Correspondence Regarding Cultural Resource and
Tribal Coordination

**Re: SR 519 INTERMODAL ACCESS PROJECT,
PHASE 2: ATLANTIC CORRIDOR**

Log: 050307-04-FHWA
Property: SR 519 Intermodal Access
Re: Archaeology - APE Concur

Log: 050307-04-FHWA
Property: SR 519 Intermodal Access
Re: NO Adverse Effect

Figure 1. SR 519 area of potential effects (APE).

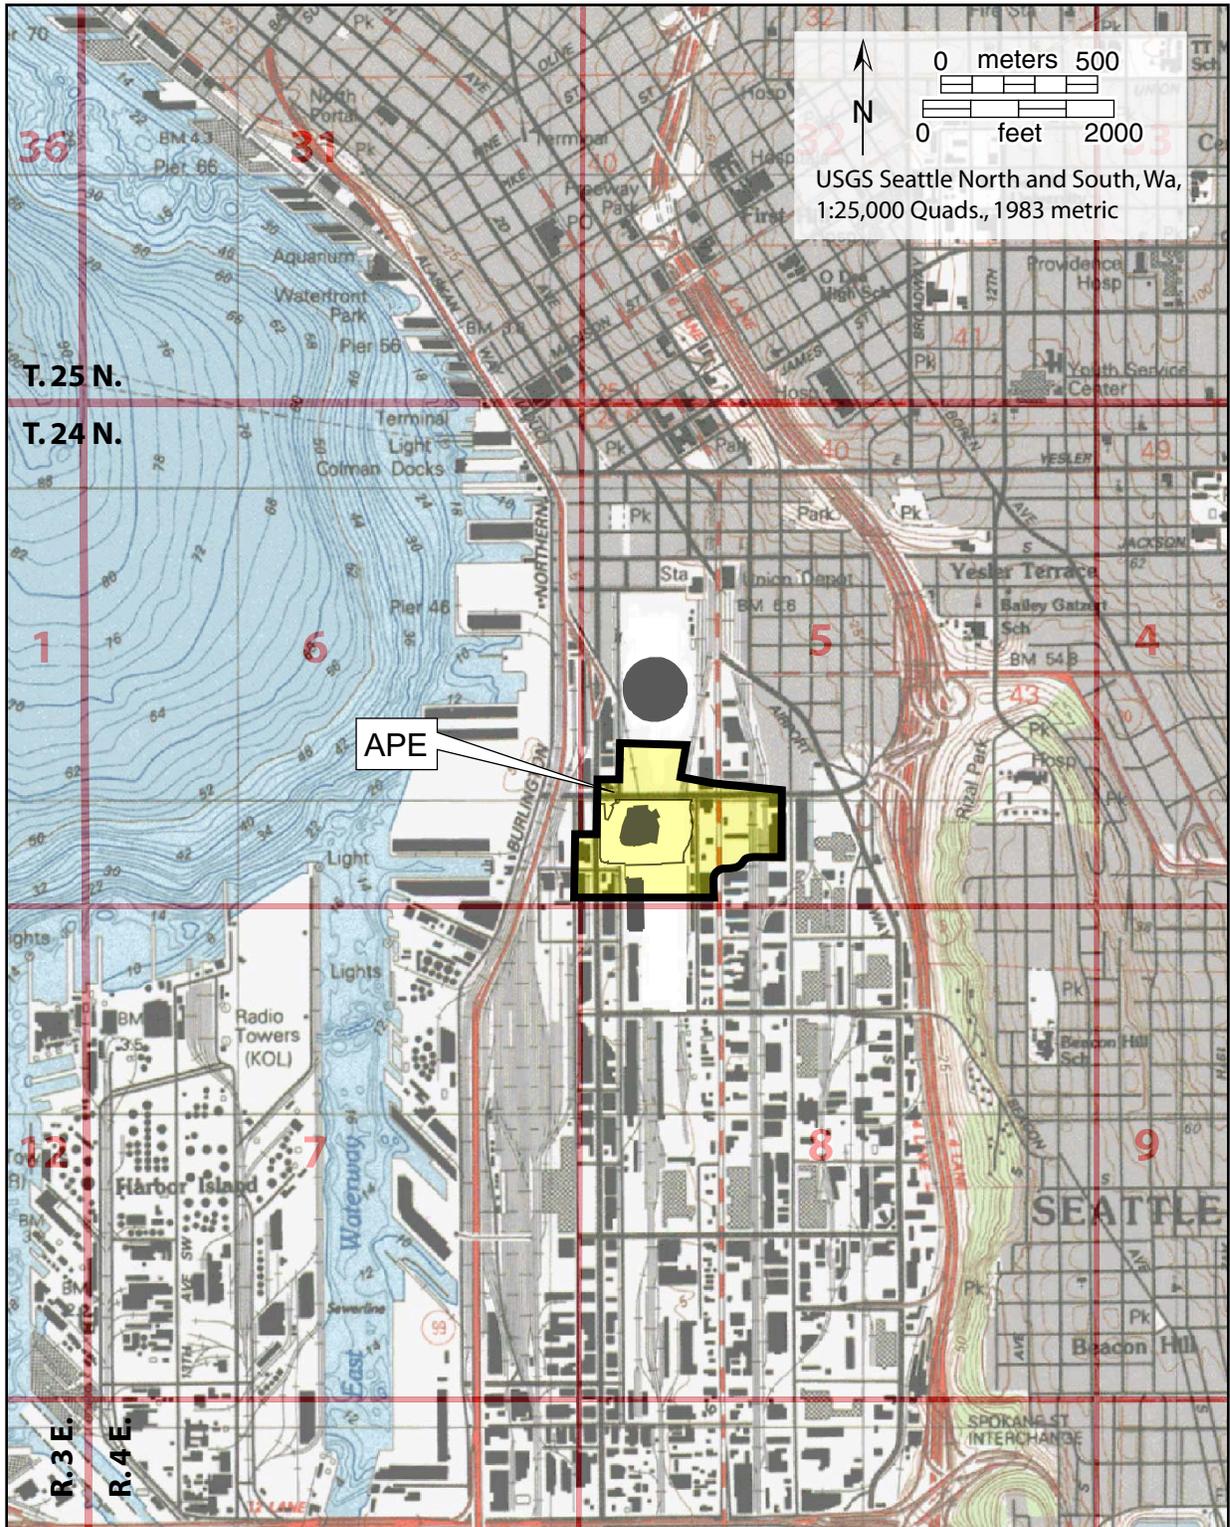
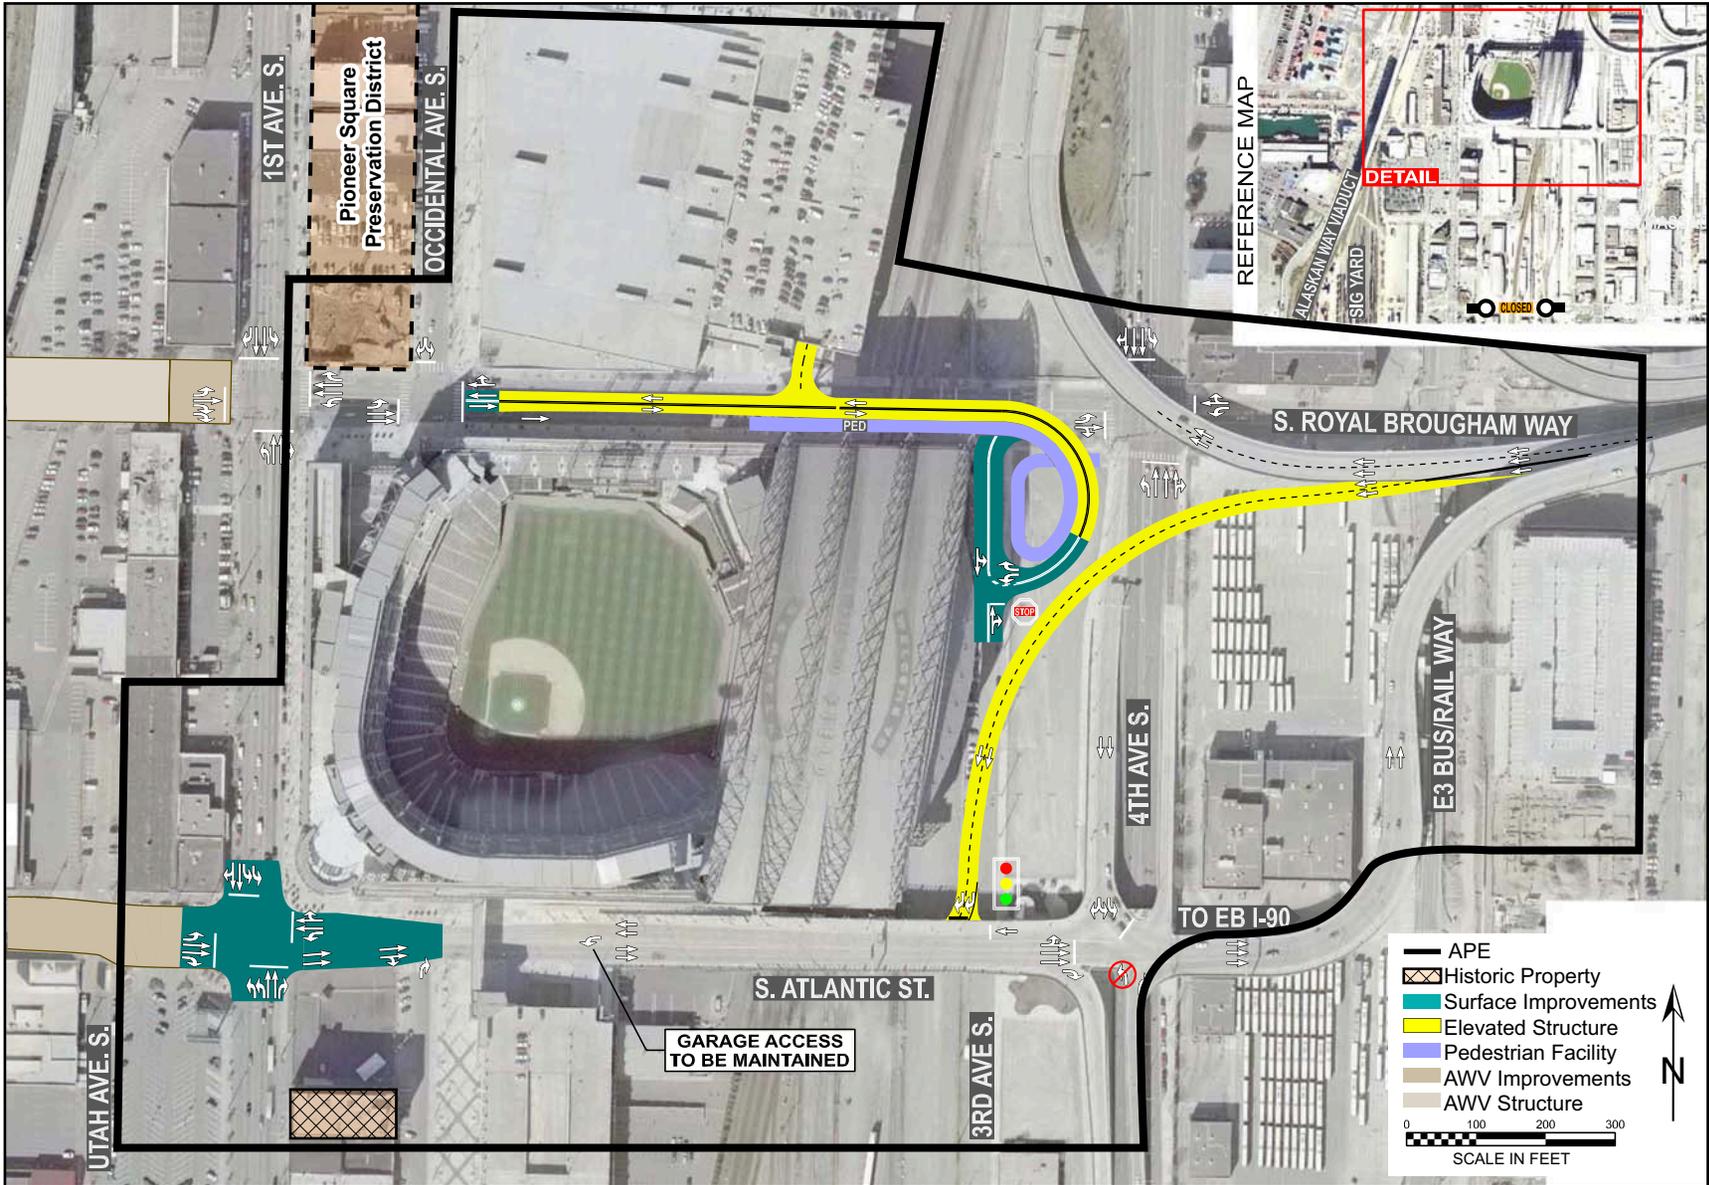
We have reviewed the materials forwarded to our office for the SR 519 Intermodal Access project. Thank you for your description of the area of potential effect (APE) for the project. We concur with the definition of the APE. We look forward to the results of your cultural resources survey efforts, your consultation with the concerned tribes, and receiving the survey report. We would appreciate receiving any correspondence or comments from concerned tribes or other parties that you receive as you consult under the requirements of 36CFR800.4(a)(4) and the survey report when it is available.
